ARCHITECTURAL DRAWINGS

84 - 88 BIRRIGA ROAD
BELLEVUE HILL, NSW, 2023

PROPOSED NEW APARTMENT DEVELOPMENT OVER 2 BUILDINGS SET ON 2 ADJACENT LOTS,
INCLUDING 16 NEW APARTMENTS AND ASSOCIATED LANDSCAPING WORKS

2 DEVELOPMENT APPLICATION

A: GROUND FLOOR PLAN / B: ROOF - KEY PLAN

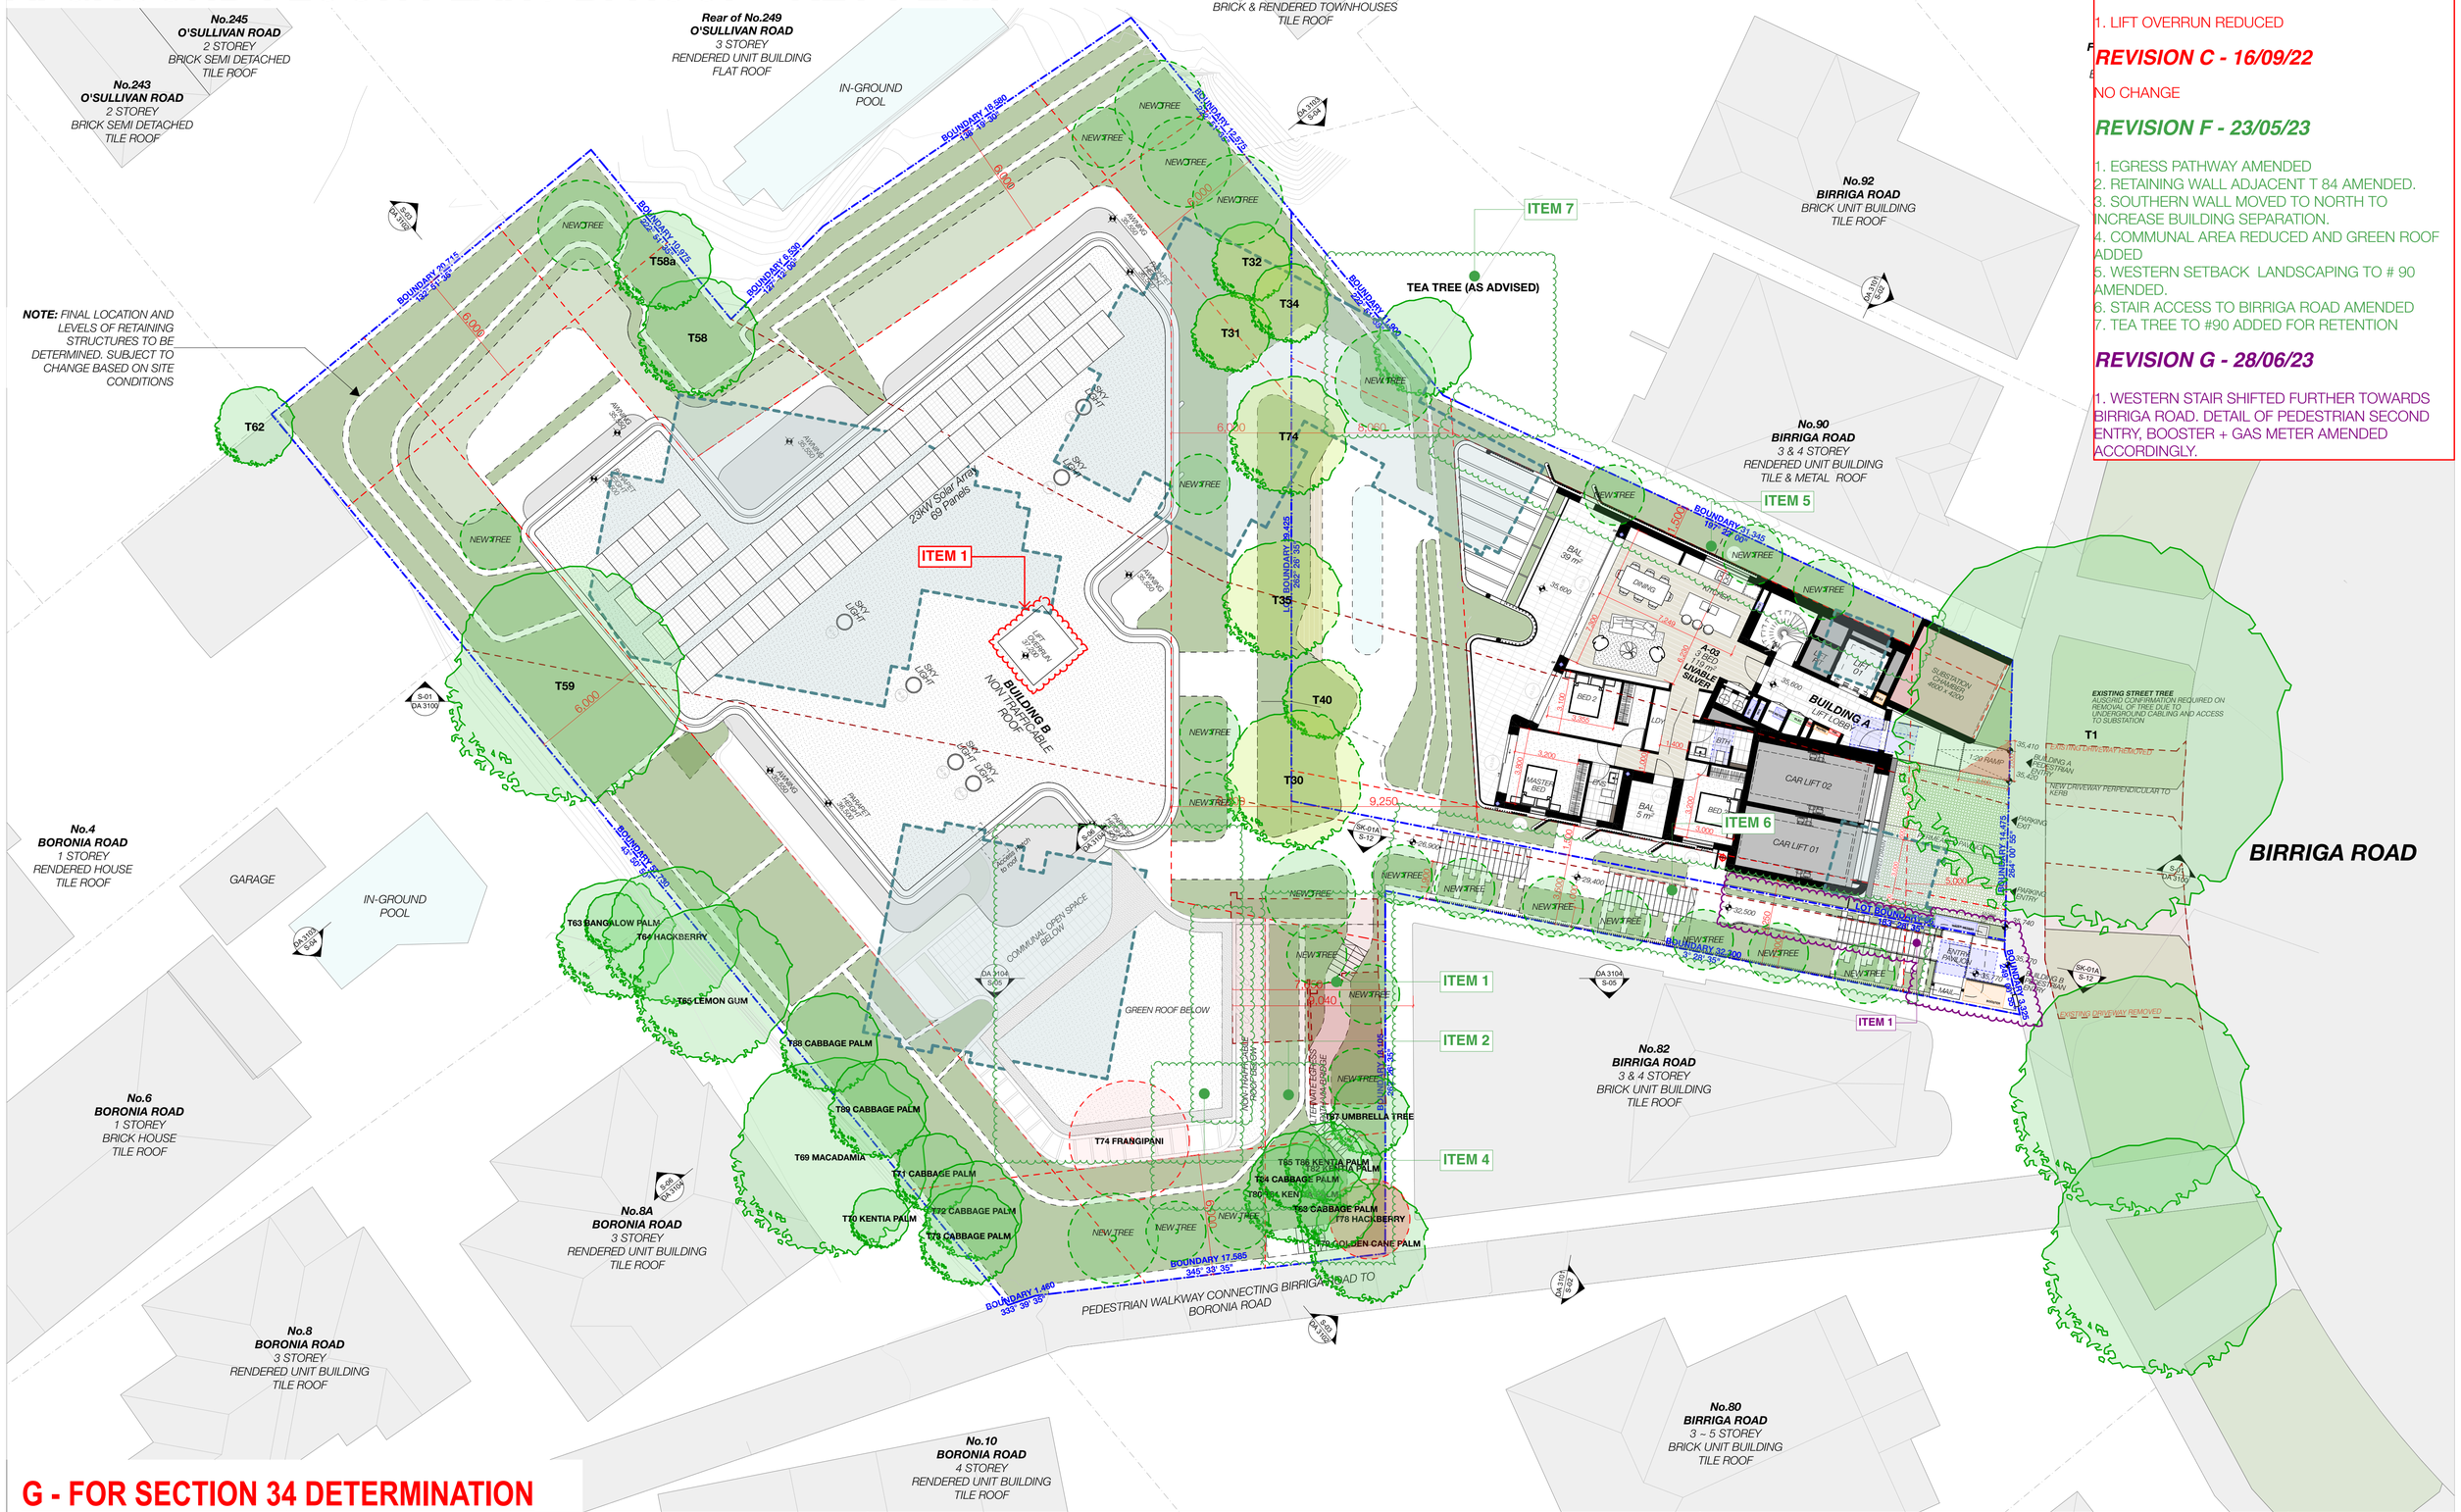
1. EGRESS PATHWAY AMENDED
2. RETAINING WALL ADJACENT T 84 AMENDED.
3. SOUTHERN WALL MOVED TO NORTH TO INCREASE BUILDING SEPARATION.
4. COMMUNAL AREA REDUCED AND GREEN ROOF ADDED
5. WESTERN SETBACK LANDSCAPING TO # 90 AMENDED.
6. STAIR ACCESS TO BIRRIGA ROAD AMENDED
7. TEA TREE TO #90 ADDED FOR RETENTION

1. WESTERN STAIR SHIFTED FURTHER TOWARDS BIRRIGA ROAD. DETAIL OF PEDESTRIAN SECOND ENTRY, BOOSTER + GAS METER AMENDED ACCORDINGLY.

A: LEVEL 02 PENTHOUSE FLOOR - KEY PLAN

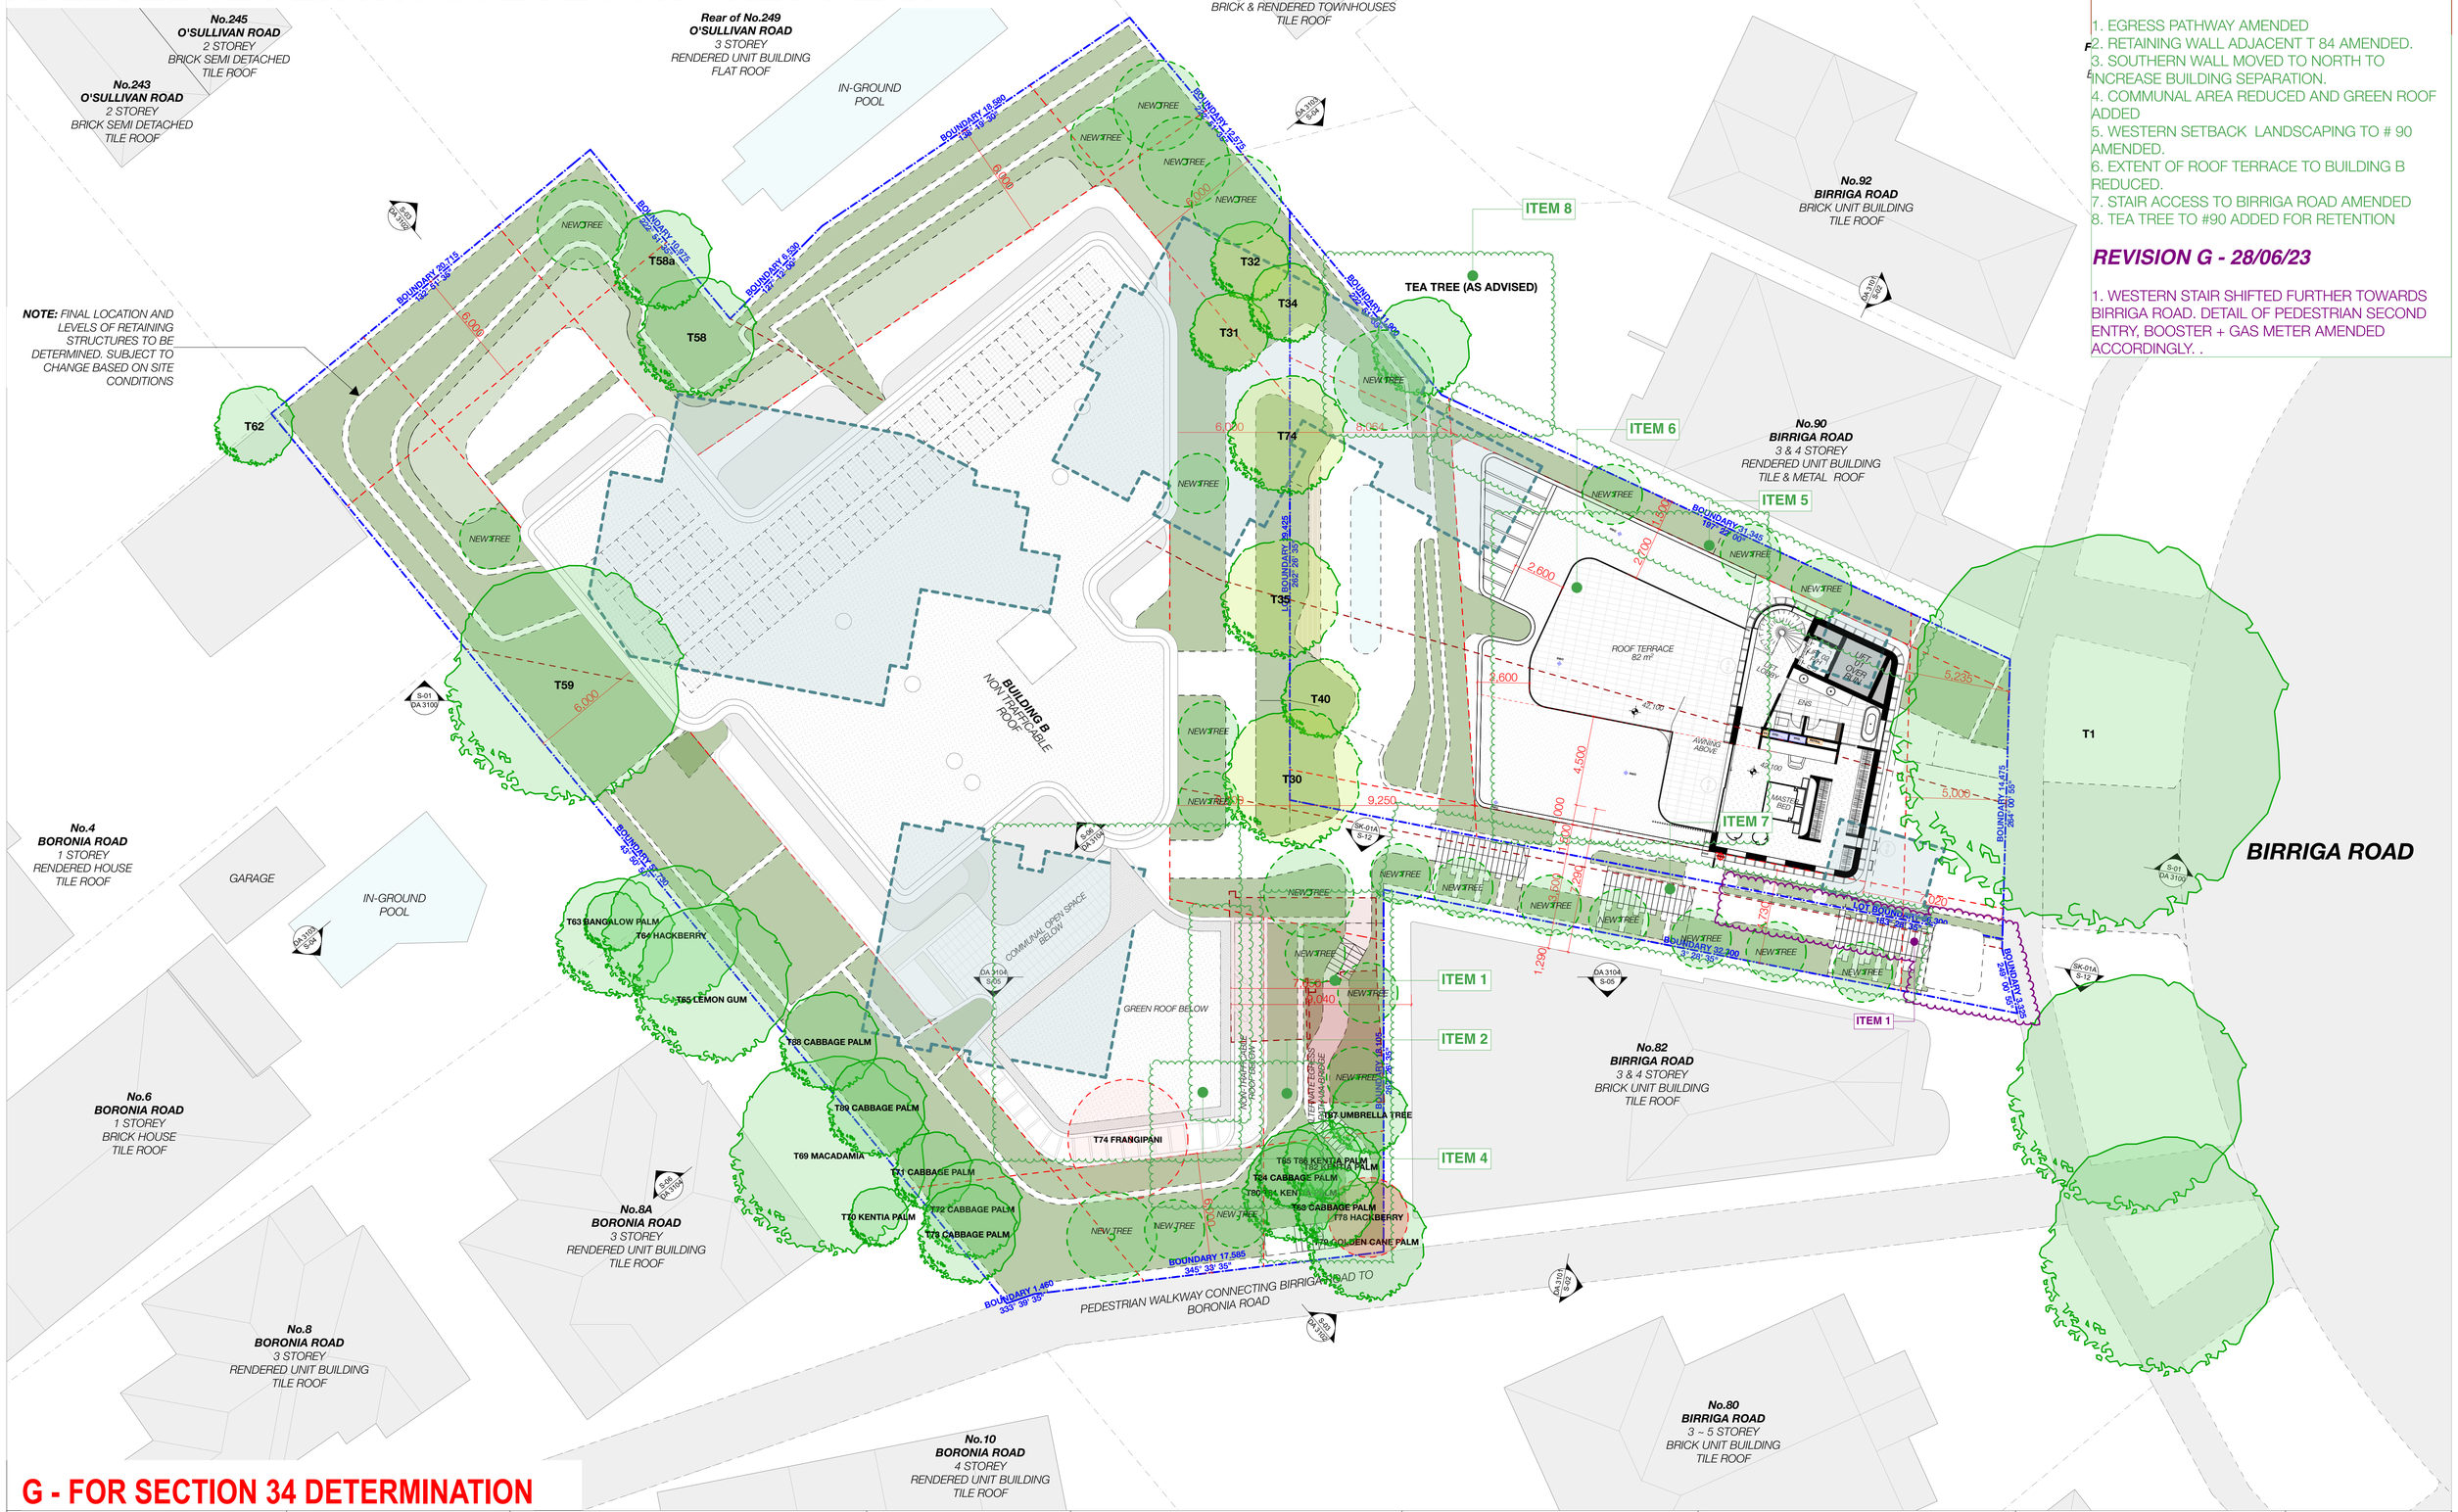
1. EGRESS PATHWAY AMENDED
2. RETAINING WALL ADJACENT T 84 AMENDED.
3. SOUTHERN WALL MOVED TO NORTH TO INCREASE BUILDING SEPARATION.
4. COMMUNAL AREA REDUCED AND GREEN ROOF ADDED
5. WESTERN SETBACK LANDSCAPING TO # 90 AMENDED.
6. EXTENT OF ROOF TERRACE TO BUILDING B REDUCED.
7. STAIR ACCESS TO BIRRIGA ROAD AMENDED
8. TEA TREE TO #90 ADDED FOR RETENTION

1. WESTERN STAIR SHIFTED FURTHER TOWARDS BIRRIGA ROAD. DETAIL OF PEDESTRIAN SECOND ENTRY, BOOSTER + GAS METER AMENDED ACCORDINGLY. .

A: GROUND FLOOR PLAN / B: ROOF PLAN

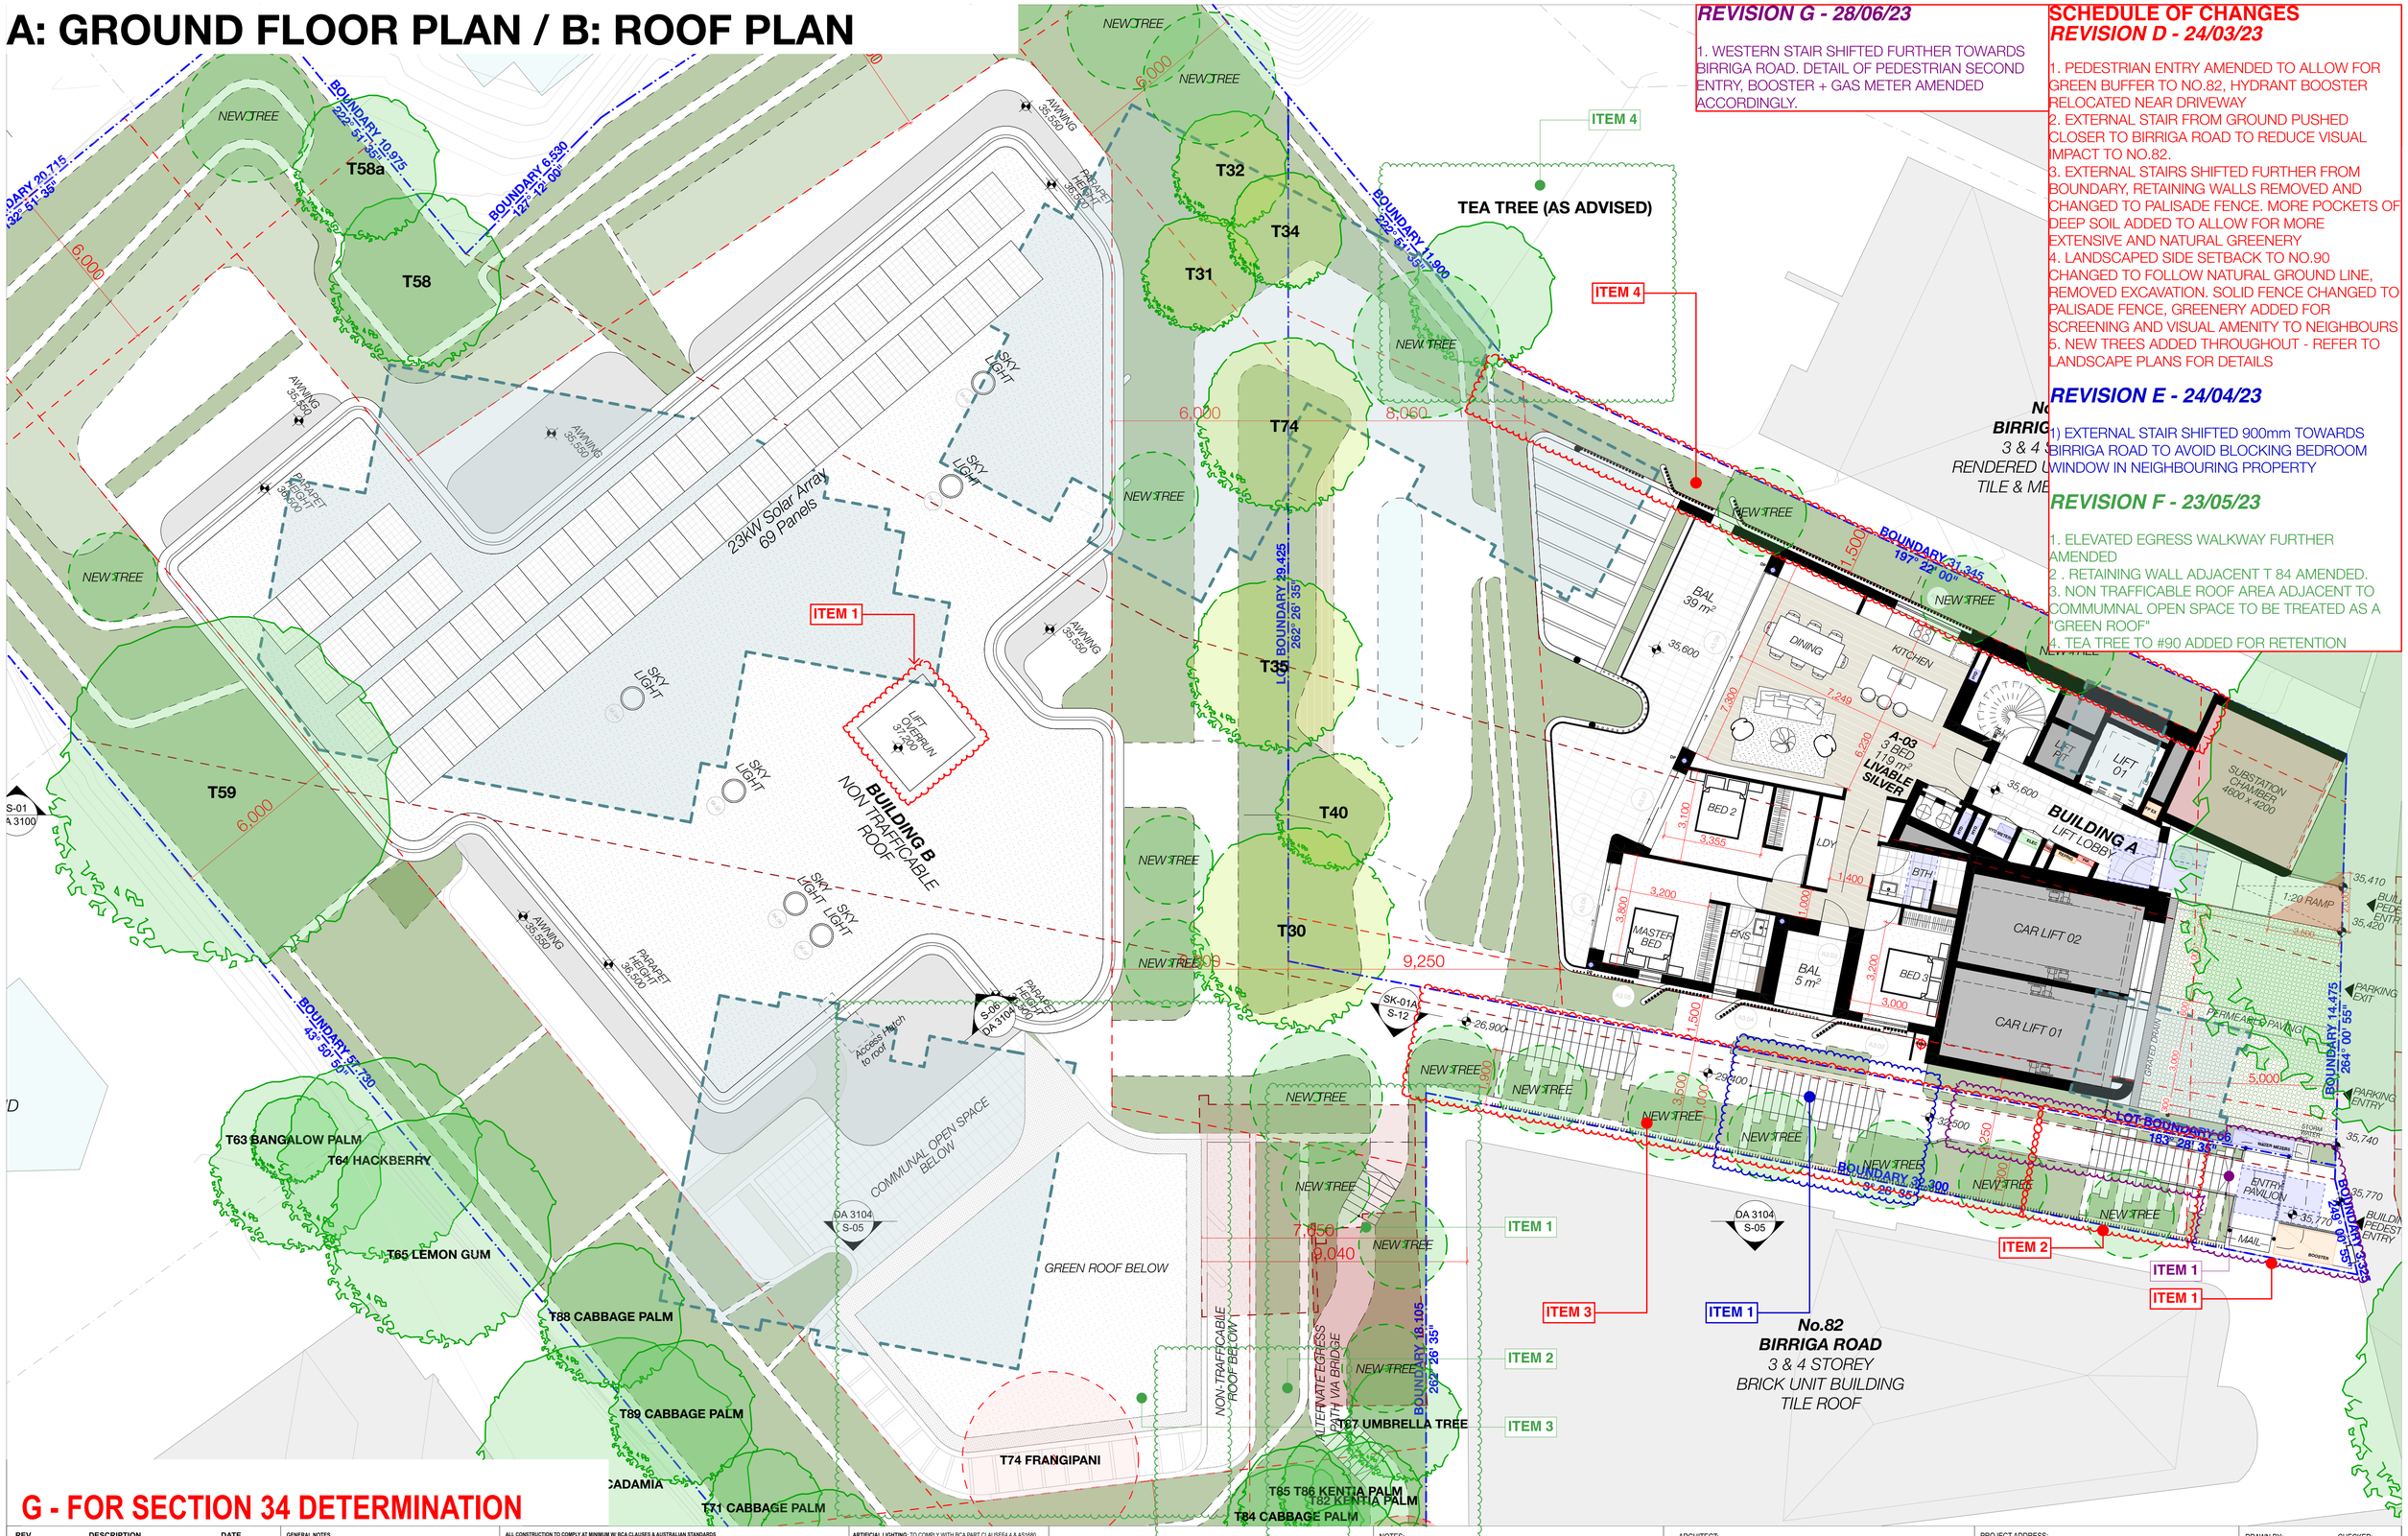
1. WESTERN STAIR SHIFTED FURTHER TOWARDS BIRRIGA ROAD. DETAIL OF PEDESTRIAN SECOND ENTRY, BOOSTER + GAS METER AMENDED ACCORDINGLY.
